# SUPPLEMENTAL INSTRUCTION

PROJ.: **Boys and Girls Club Prince of Wales**  
PROJ. No.: **1716**  
DATE: **June 14, 2018**  
S.I. No. **S.I. - 029**

Revision to Rain Water Leader at Gym, New Sanitary Connections

## **Mechanical Contemplated Change Notice (MCCN)**

DRAWING: **GROUND PLUMBING MODIFICATIONS**

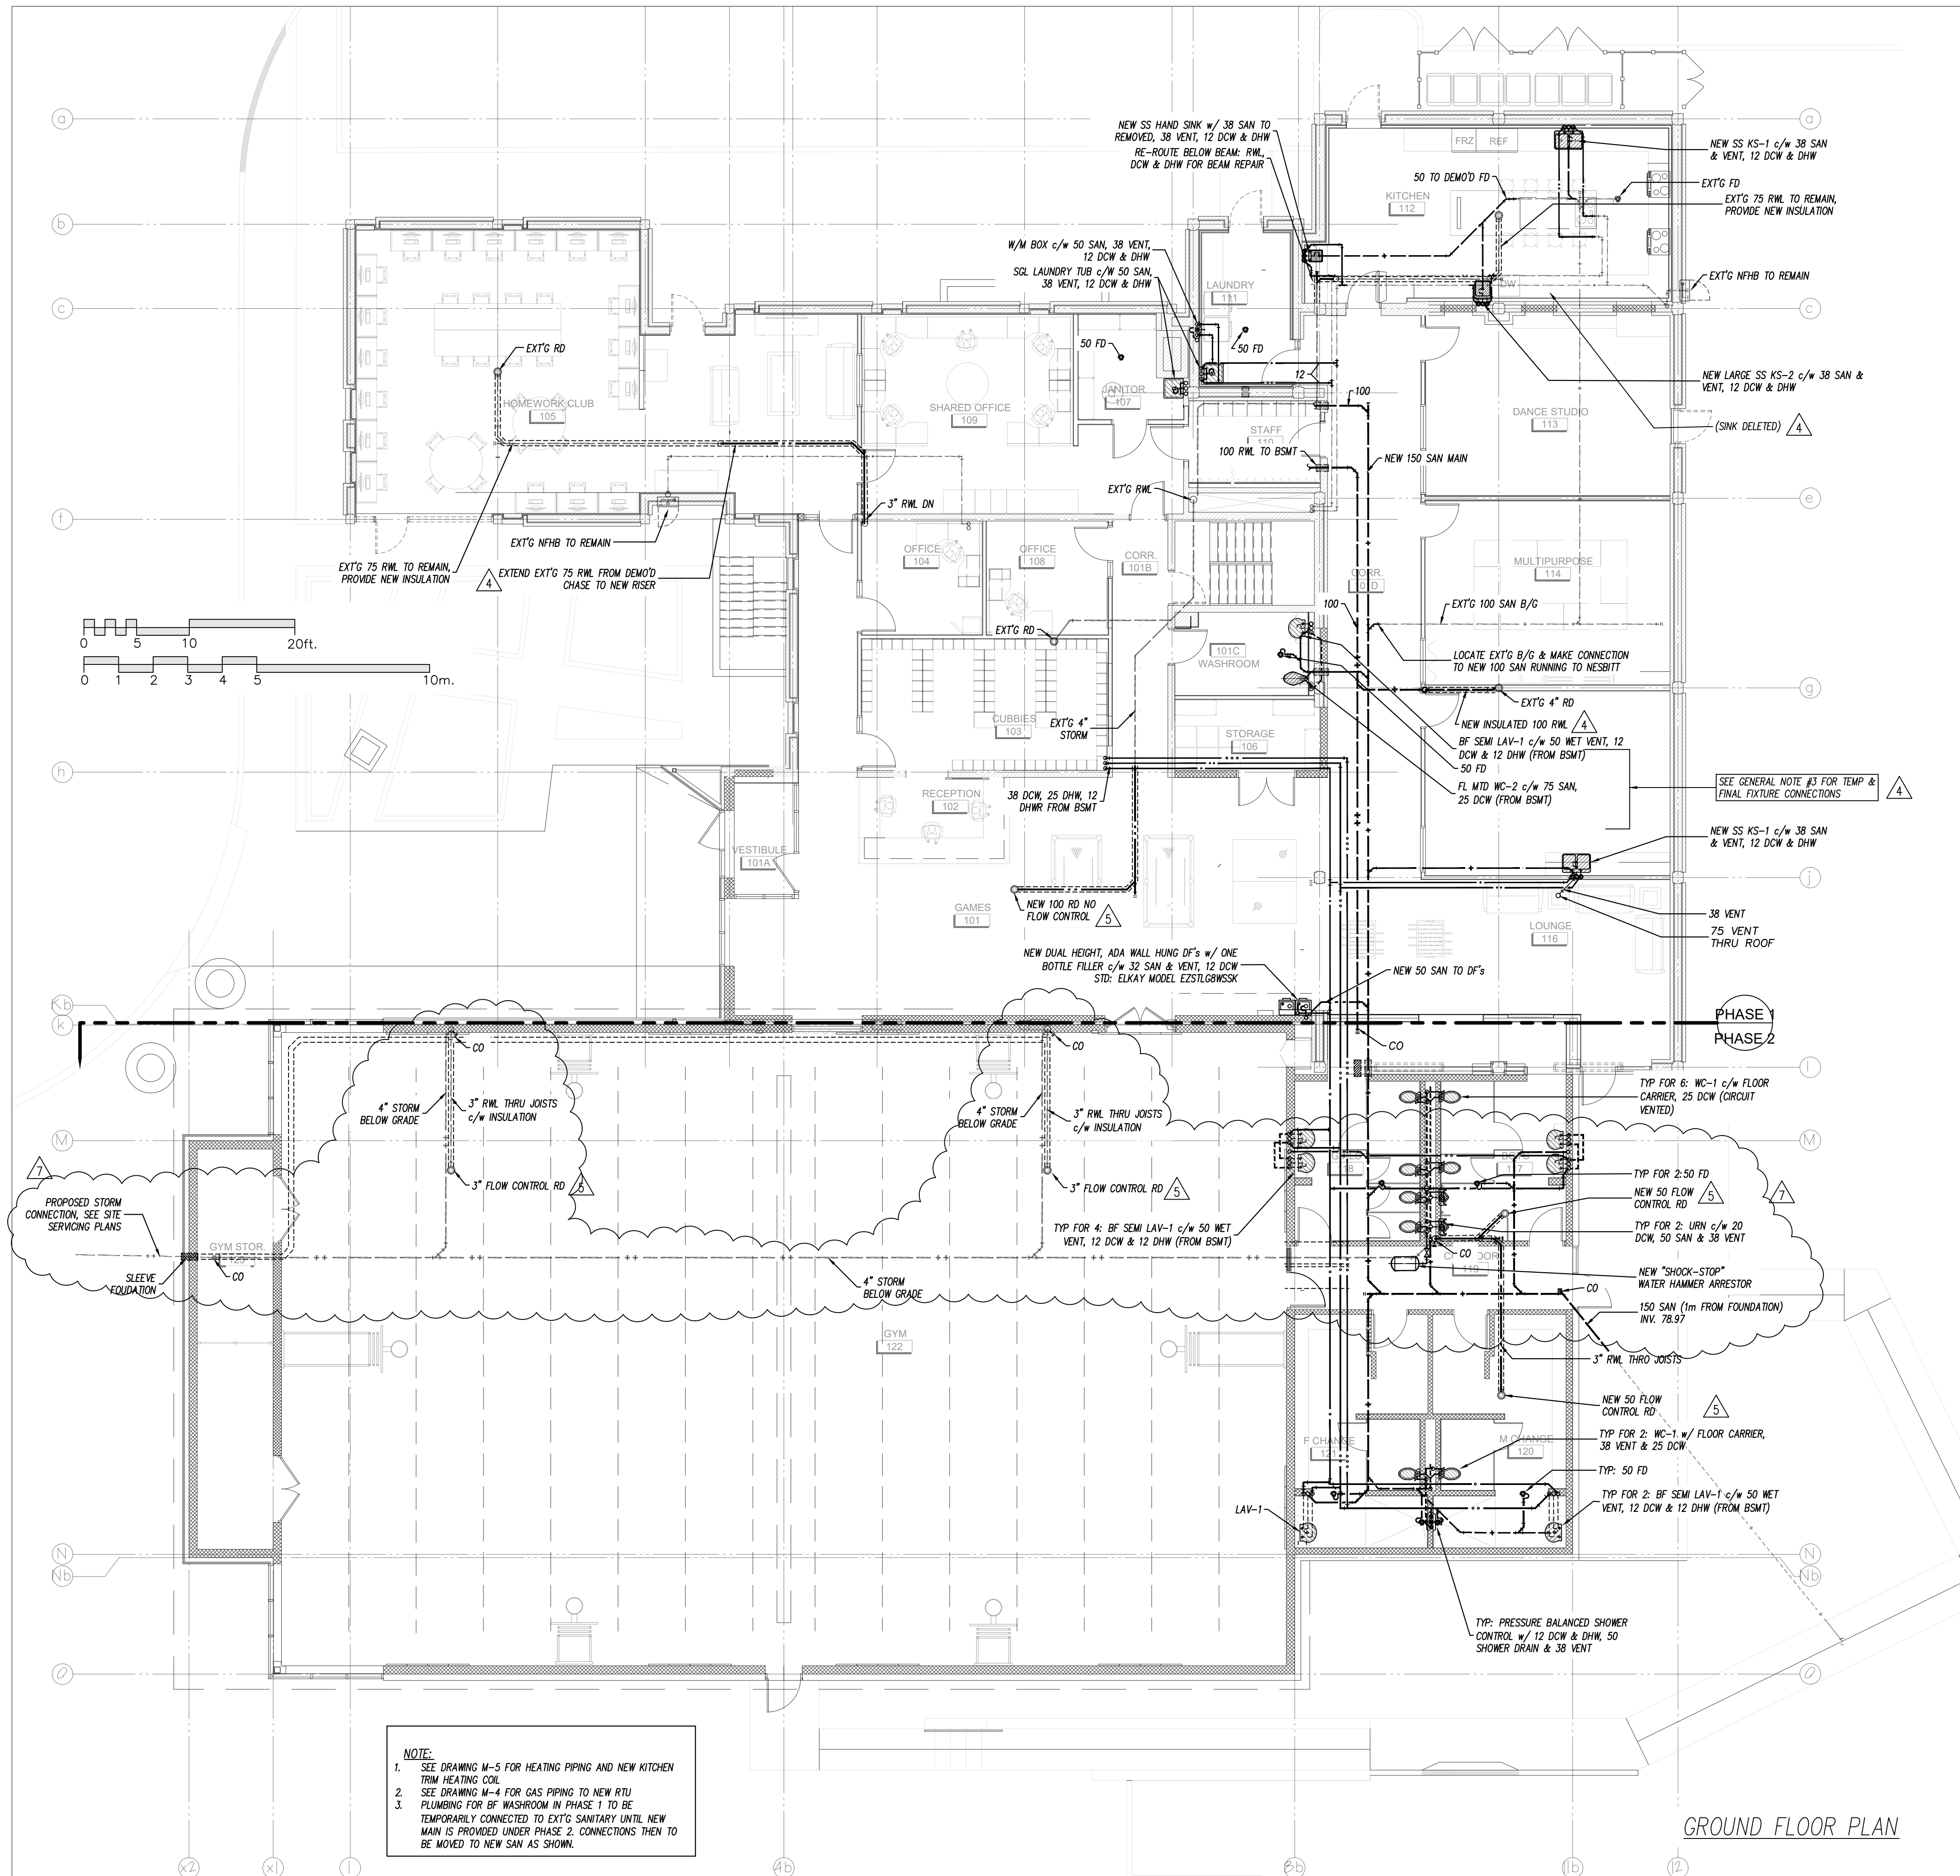
1. See M-6 Revision 7. Rain water leader routing for gym roof drains
  - a. Site service engineer directed connection of Gym Addition roof drains to be a new connection on west side of gym.
2. See M-6 Revision 7. Change room layout to accommodate revised location of site sanitary drain.
  - a. Revision to accommodate new proposed location of sanitary drain.
